**North Liberty Planning Commission
Tuesday, October 1, 2024, 6:30 PM
North Liberty City Council Chambers
360 N Main St, North Liberty, Iowa 52317**

To **City of North Liberty Planning Commission**
 From **Ryan Rusnak, AICP**
 Date **September 27, 2024**
 Re **Request of Buck Moon Villas, LLC to approve a Preliminary Site Plan for 11 townhouse units in three buildings on 1.6 acres. The property is located on the east side of North Dubuque Street approximately 300 feet southeast of Ranshaw Way.**

To **City of North Liberty Planning Commission**
 From **Ryan Rusnak, AICP**
 Date **May 27, 2024**
 Re **Request of North Jones, LLC for a zoning map amendment (rezoning) from RM-8 Multi-Unit Residence District to RM-12 Multi-Unit Residence District on approximately 3.53 acres. The property is located at 1605, 1655 and 1695 North Jones Boulevard.**

To **City of North Liberty Planning Commission**
 From **Ryan Rusnak, AICP**
 Date **September 27, 2024**
 Re **Request of Hodge Construction Company for a zoning map amendment (rezoning) from RM-21 Multi-Unit Residence District to C-3 Higher-Intensity Commercial District on approximately 5.12 acres. The property is located at the northeast c

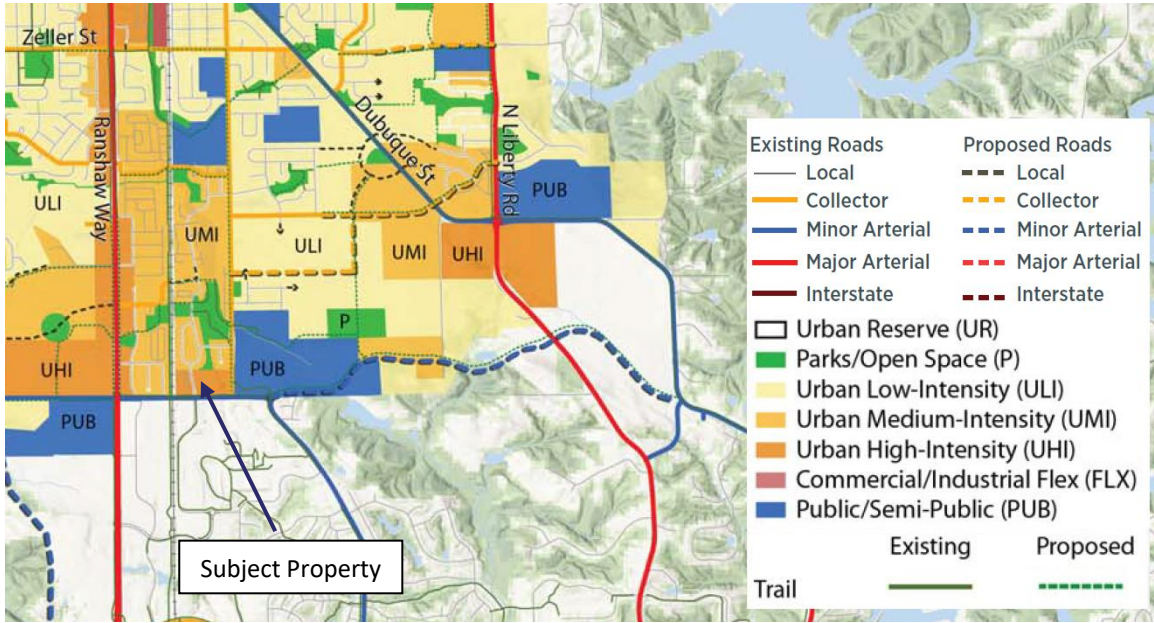
A primary consideration is the appropriateness of C-3 in this location. The property is designed Urban High Intensity (UHI) on the Future Land Use Map (FLUM). C-3 would be consistent with the FLUM.

The UHI Future Land Use Map designation was chosen for this and the adjacent properties due to the existing RM-21 Zoning and that Forevergreen Road is an arterial roadway, with planned extension to North Liberty Road and Dubuque Street.

It is staff's opinion that the zoning map amendment would achieve consistency with the Comprehensive Plan and adopted land use policies.

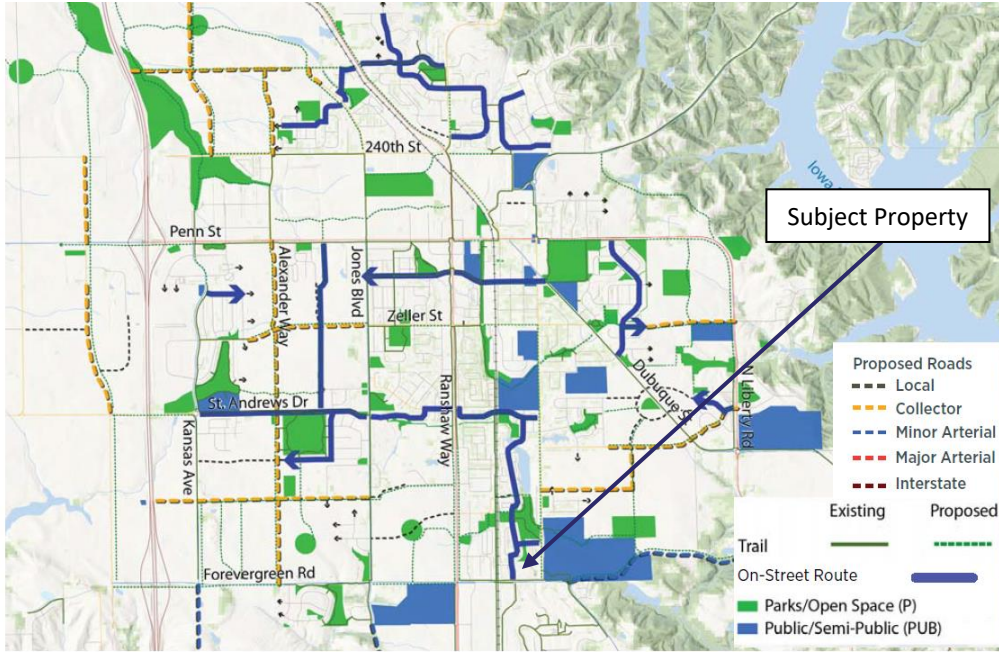
The concept provided to City staff shows 234 residential units in three buildings (45.6 units/acre). To maximum density and meet off-street parking standards, the building would be a "4 over 1", which is four-stories of wood framing over a concrete platform. Wood framing is less expensive than steel or metal framing or using entirely concrete. The concrete base allows builders to construct a building that is one story taller than would normally be allowed for entirely wood-framed buildings under building code.

Staff recognizes that the proposed development is on the higher end of residential density. Certainly, this density wouldn't be appropriate in all locations within the City. However, staff advocates for higher density and intensity in appropriate locations. This was considered when creating the North Liberty Connected to Tomorrow Comprehensive Plan Future Land Use Map, which was adopted in February 2023.

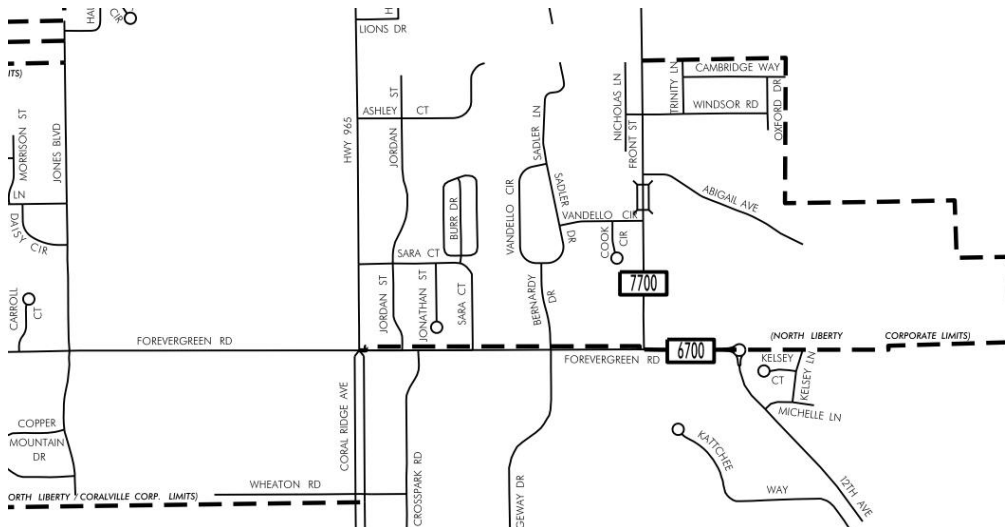
The anticipated vehicle trips for mid-rise multi-family development is 5.44 per day. The concept provided to City staff shows 234 residential units in three buildings, which equates to 1,272 vehicle trips per day at full build out. Below is a map showing 2022 DOT traffic counts, which 6,700 vehicles trips per day. This is well below the maximum roadway capacity of this roadway segment.

Staff reached out to the City of Coralville regarding the anticipated future of the Forevergreen Road/Front Street intersection since it maintains this section of Forevergreen Road. The City Engineer indicated that they expect this intersection to become a roundabout at some point. Additionally, he indicated that the Coralville Youth Sports Park will eventually have a secondary access along Forevergreen Rd and that ideally, a fourth leg of the roundabout could become the secondary access (yellow). This would require some property acquisition.
